RE: Review of revised percolation plan- **A516945**  
Breezewood Farms, Sec. 4  
Lot 16, Breezewood Drive  
Re-test of Non-Buildable Lot

RE: Percolation test results- A516945  
Breezewood Farms, Sect. 4  
Lot 16, Breezewood Drive  
Re-test of Non-Buildable Lot

SITE INSPECTION SHEET

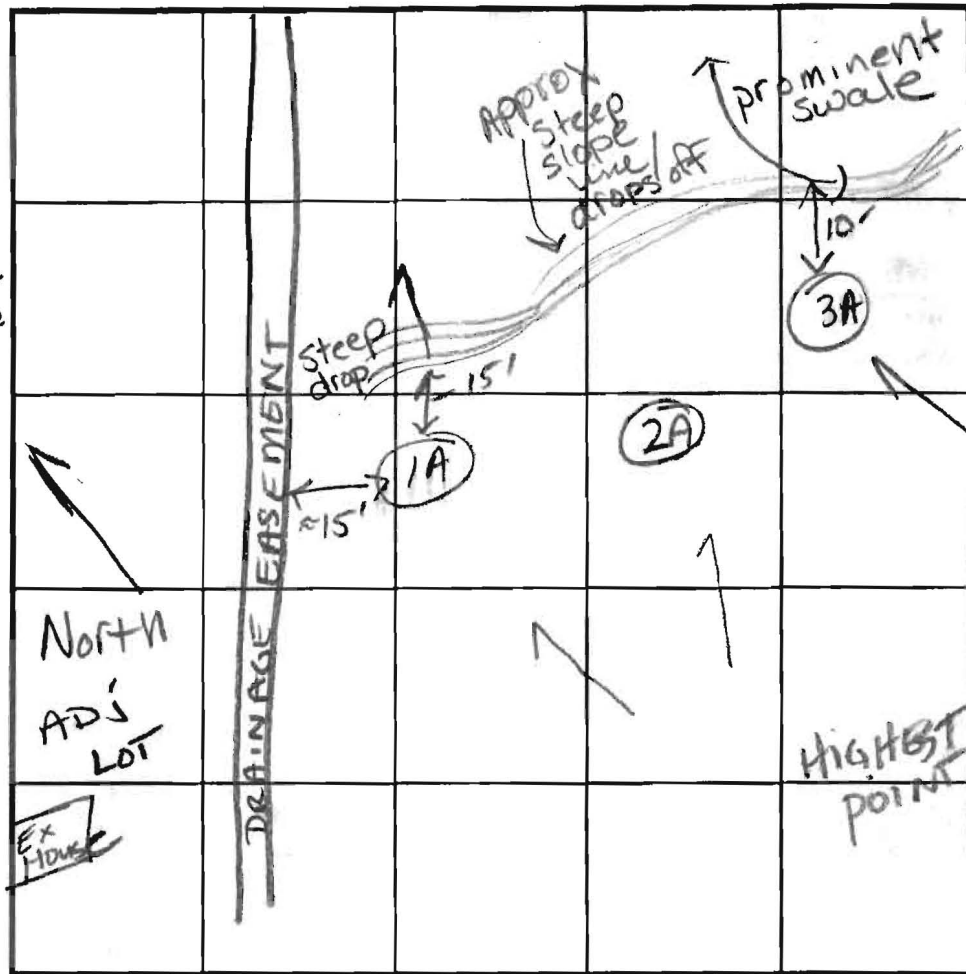
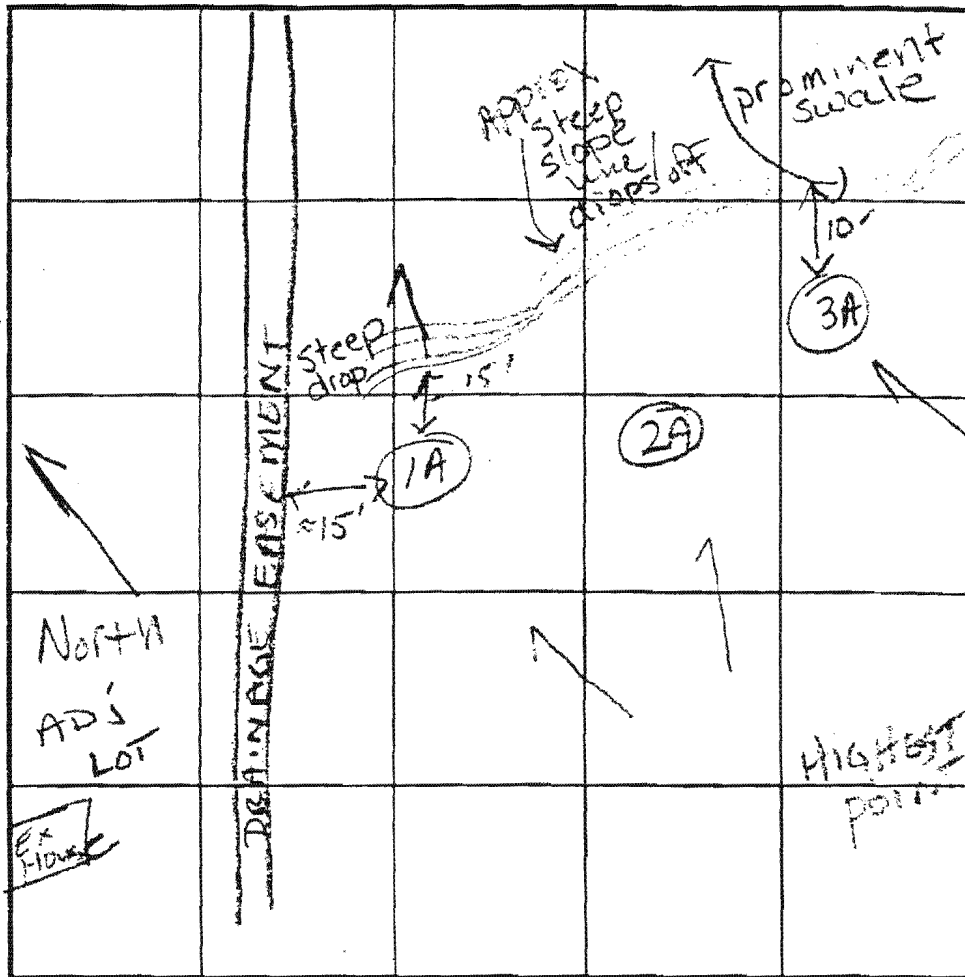
DATE	TEST NO.	DEPTH	PRE-WET		TEST - 1" DROP		TIME
			START	STOP	START	STOP	
2-5-03	3A	3'5"	11:20 <sup>47</sup>	11:21 <sup>30</sup>	11:21 <sup>30</sup>	11:23 <sup>30</sup>	2 min ok
	2A	2 1/2' S	11:28 <sup>45</sup>	11:31 <sup>24</sup>	11:31 <sup>24</sup>	11:34 <sup>50</sup>	3+ ok
	1A	Visual	SEE	SOIL	PROFILE		OK
<p>- NEED TO FIELD - LOCATE TEST HOLES AND IDENTIFY NEARBY SLOPES AND SWALES.            - TEST HOLES SMALLER THAN STD.</p>

DATE	TEST NO.	DEPTH	PRE-WET		TEST - 1" DROP		TIME
			START	STOP	START	STOP	
2-5-03	3A	3'S	11:20 <sup>47</sup>	11:21 <sup>30</sup>	11:21 <sup>30</sup>	11:23 <sup>30</sup>	2 min ok
	2A	2 1/2'S	11:28 <sup>45</sup>	11:31 <sup>24</sup>	11:31 <sup>24</sup>	11:34 <sup>50</sup>	3+ ok
	1A	Visual	SEE	SOIL	Profile		ok
- NEED TO FIELD - LOCATE TEST HOLES AND IDENTIFY NEARBY SLOPES AND SWALES. - TEST HOLES SMALLER THAN STD.

LOT 16

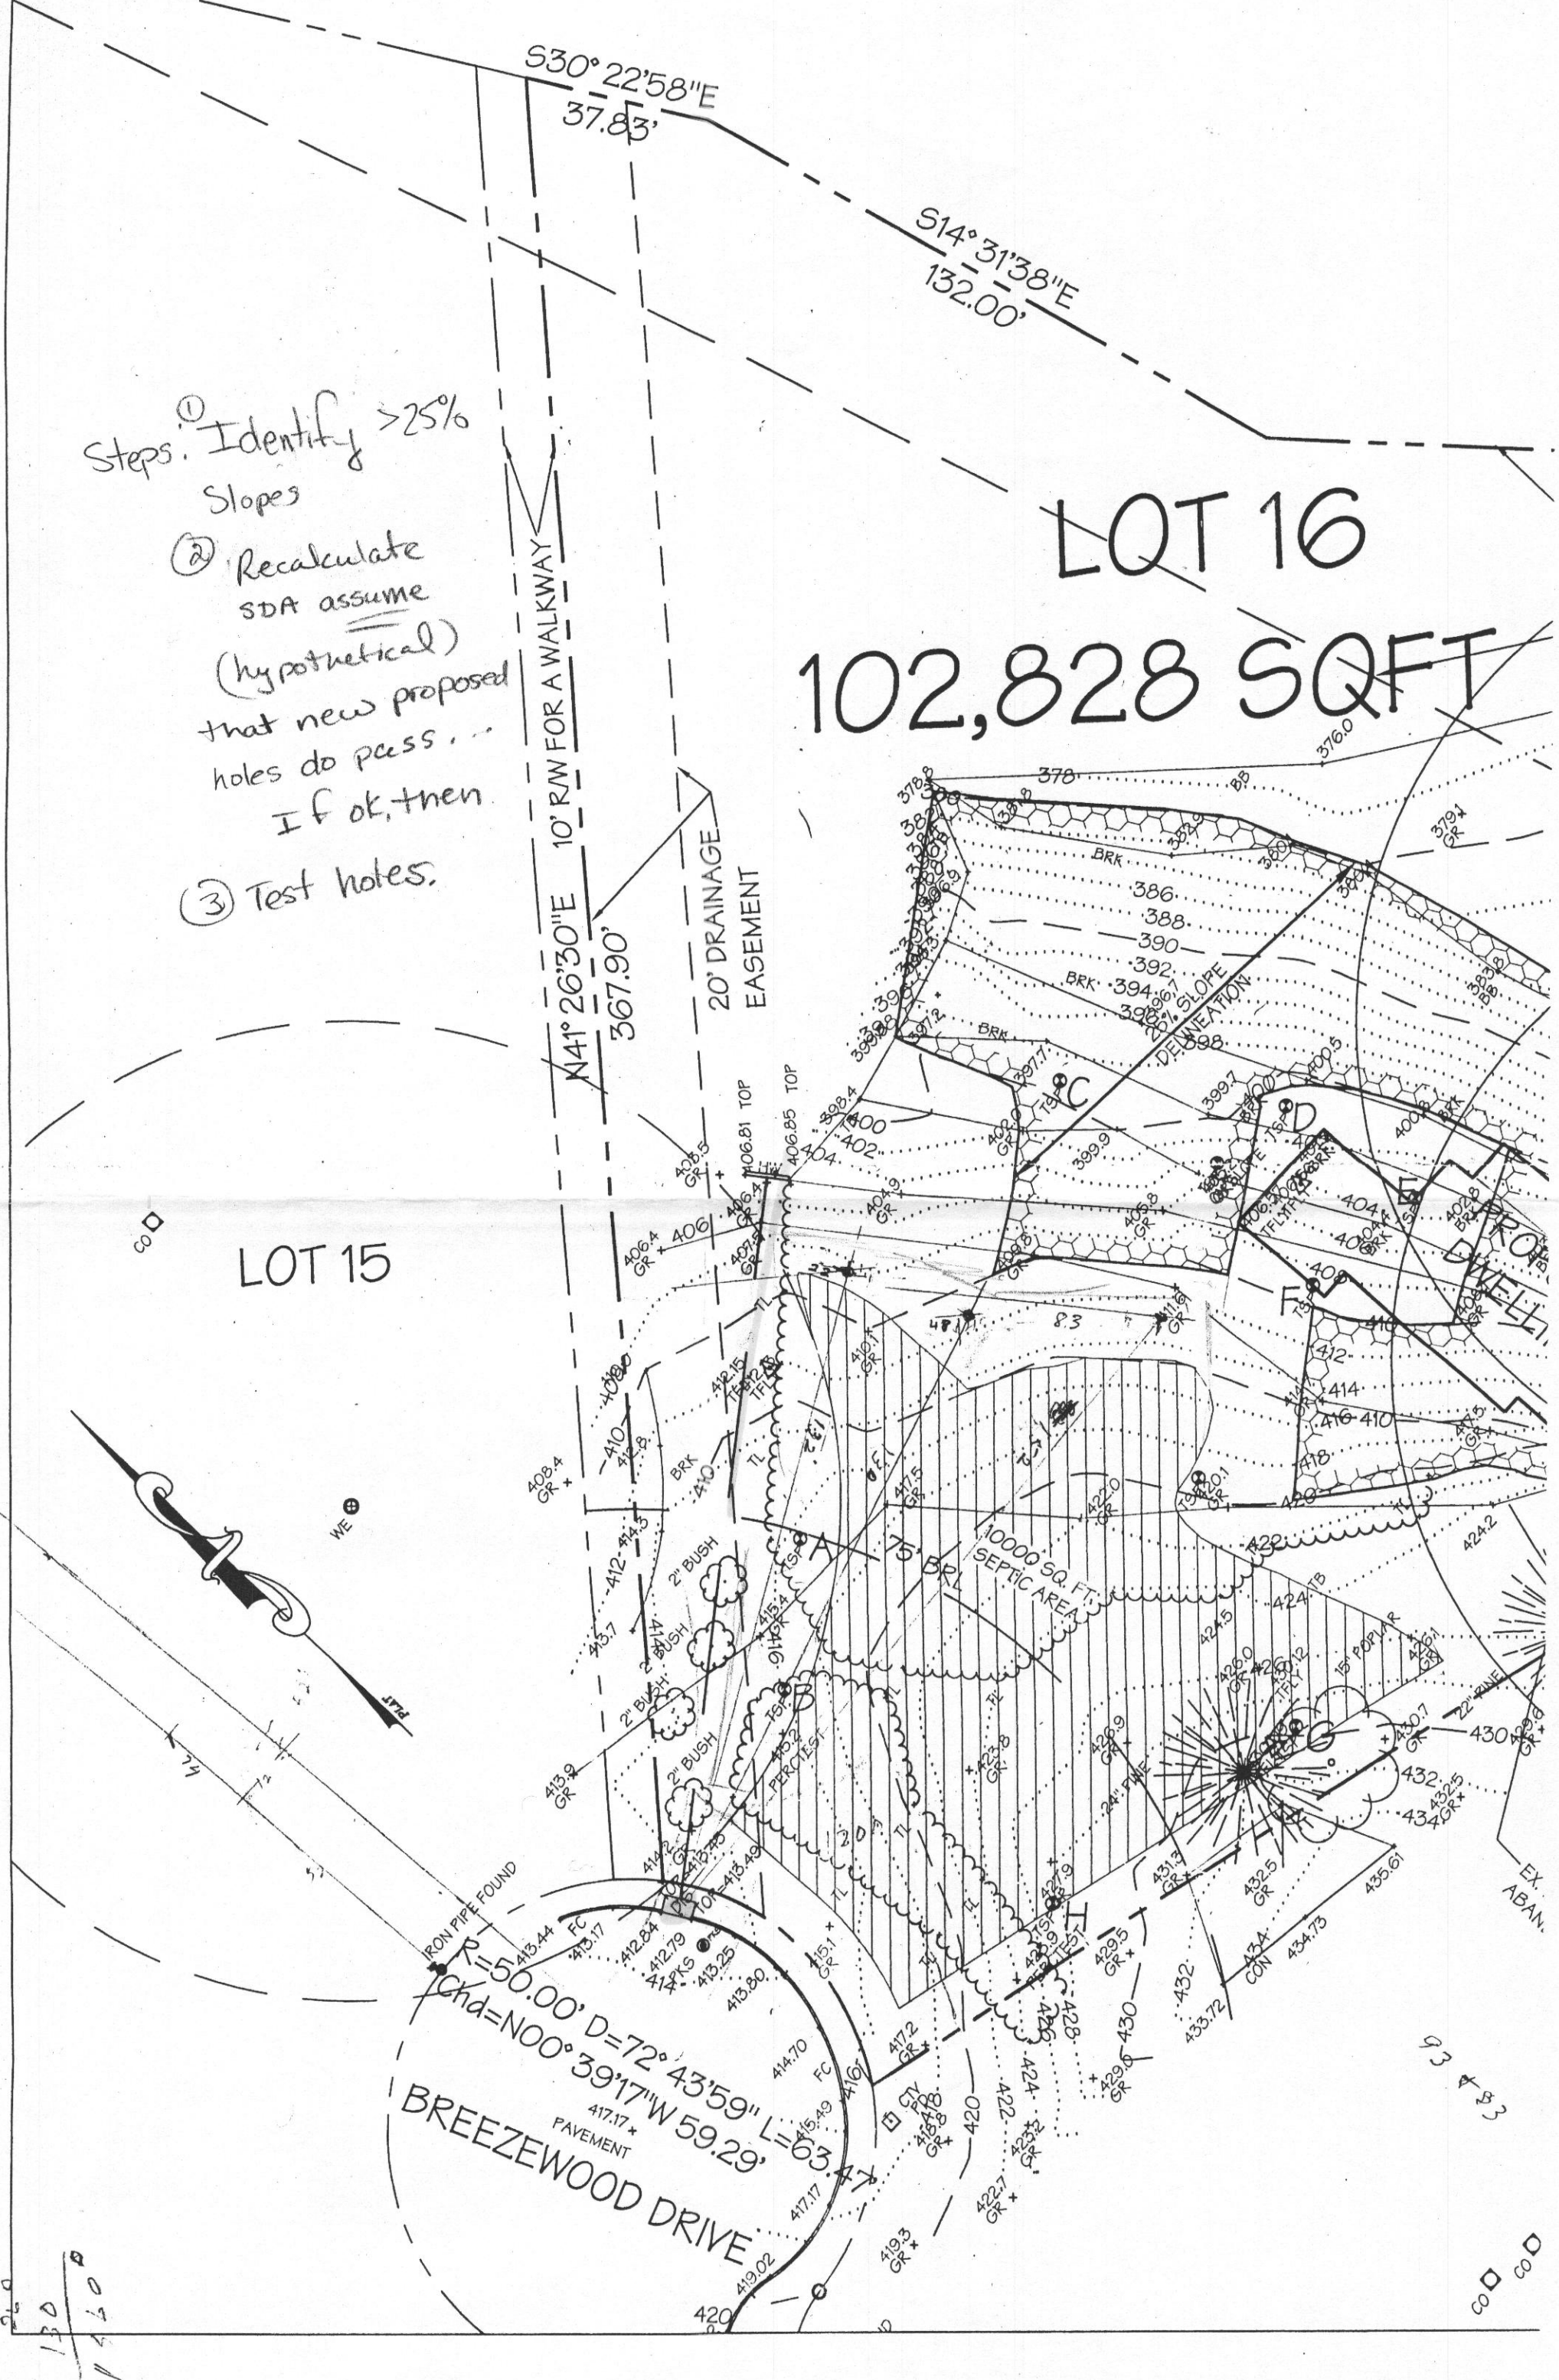
Our office received a revised percolation test plan on December 19, 2002 from LDE, Inc. The plan shows revisions indicating slopes in or near the proposed septic area of 30 to 40%. As stated in COMAR 26.04.02.04, "An on site disposal system and recovery area may not be located in flood plain or slopes in excess of 25 %". Also stated in the same section of COMAR is the separation distance to steep slopes of 25 feet. Due to the down slope location of a neighboring well on the northeast side of the referenced property, the licensed engineer made adjustments to the proposed septic disposal area accordingly. However, due to the adjustments made for slopes and the adjacent well, the necessary 10, 000 square-foot easement cannot be established. Because of the difficulty of identifying an acceptable septic disposal area, our regional consultant, Barry Glotfelty, reviewed the proposal with us. At this time, we have not received a plan to adequately support the regulatory requirements nor does our review indicate an appropriate area can be delineated to meet the necessary COMAR requirements.

For further review, please have a licensed engineer submit a revised plan with the following adjustments:

- field located test holes 1a, 2a, and 3a
- field locate 25 % slopes (and greater) and also swales
- identify slopes in a legend via shading
- square-footage of proposed easement with the proper distance adjustments to prominent features (see enclosed COMAR regulations)

If the septic area encompasses 10,000 square feet, field-run topography toward the adjacent lot 's new, proposed well site would be beneficial; the contour lines will show if the well would or would not be down slope of the proposed septic easement.
